Stellaris[®] LM3S9L97 RevB1 Errata

This document contains known errata at the time of publication for the Stellaris[®] LM3S9L97 microcontroller. The table below summarizes the errata and lists the affected revisions. See the data sheet for more details.

Figure 1. Workaround Circuit to Ensure Initial Power Up

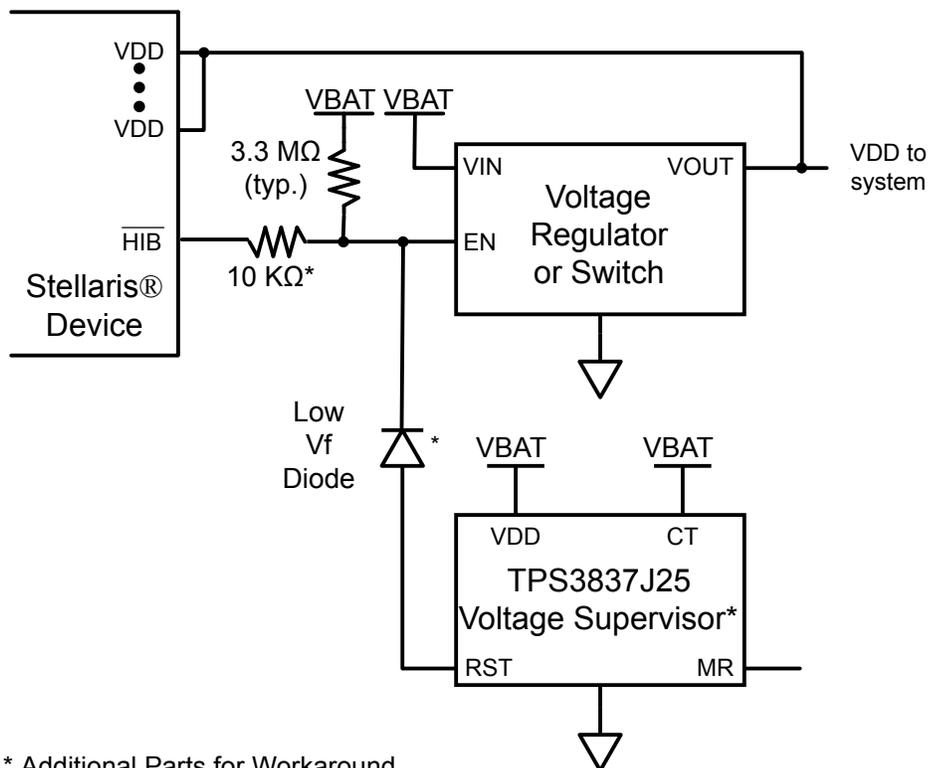
If V_{DD} is not powered when voltage is first applied to V_{BAT} , the state of the Hibernation module is indeterminate and the \overline{HIB} signal may be asserted. In this indeterminate state, a lock condition can occur in which the Hibernation module waits for a power-on-reset, but that reset cannot occur until the module deasserts \overline{HIB} . This issue is related to the errata "Hibernation module may have higher current draw than specified in data sheet under certain conditions" on page 5.

The workaround implementation depends on the system-level power supply configuration. For systems that use a battery as the primary power source, an external voltage supervisor (TPS383J25DBV or similar) circuit can be added to force the V_{DD} power supply to start when the battery voltage is first applied (see Figure 1). The voltage supervisor requires only 220 nA and generates a 200-ms positive pulse to turn on the V_{DD} regulator and activate the microcontroller's internal POR circuit.

Figure 2. Recommended Center-Tap Connections

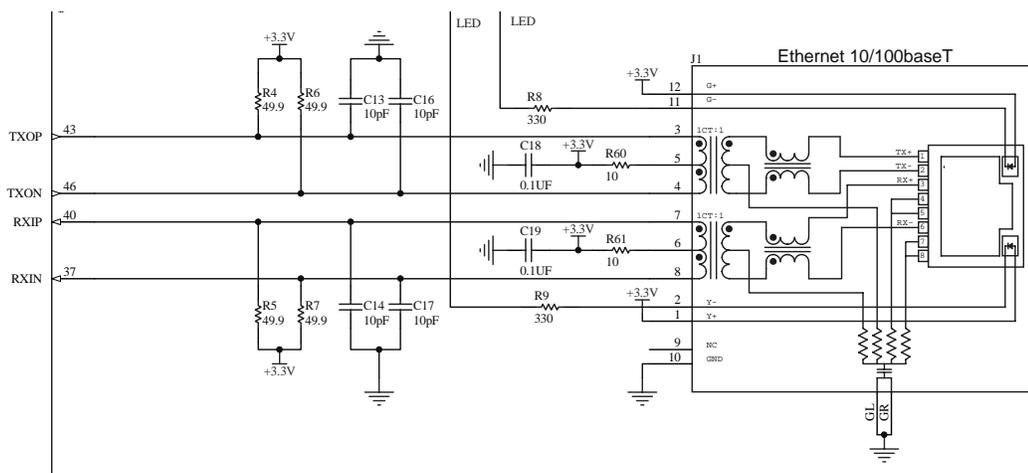
The microcontroller experiences some packet loss with Ethernet cables longer than 50 meters in normal operating conditions.

1. Add 10 Ω resistor to the center-tap of the transformer as shown in the figure. These resistors should be replaced by a direct connection for silicon that has this item fixed.
2. Continue using the recommended circuit, but limit cable lengths to 50 meters.

Figure 3. Configuration of External Regulator

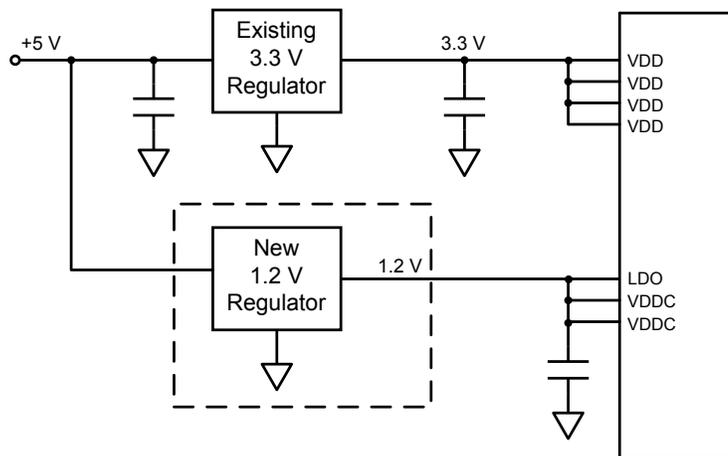
Incorrect power sequencing during power up can disrupt operation and potentially cause device failure.

V_{DDC} must be applied approximately 50 μs before V_{DD} . Normally V_{DDC} is controlled by the part's internal LDO voltage regulator. The workaround requires the addition of an external regulator (see Figure 3) to ensure that V_{DDC} sequencing requirements are met (see Figure 4). Recommended regulators include FAN1112SX (SOT223) and FAN2558S12X (SOT23-5).

This fix mitigates the on-chip power issue, but does not solve it completely. During development, the Flash memory should also be reprogrammed (using LMflash or another programming tool) at least once a week.
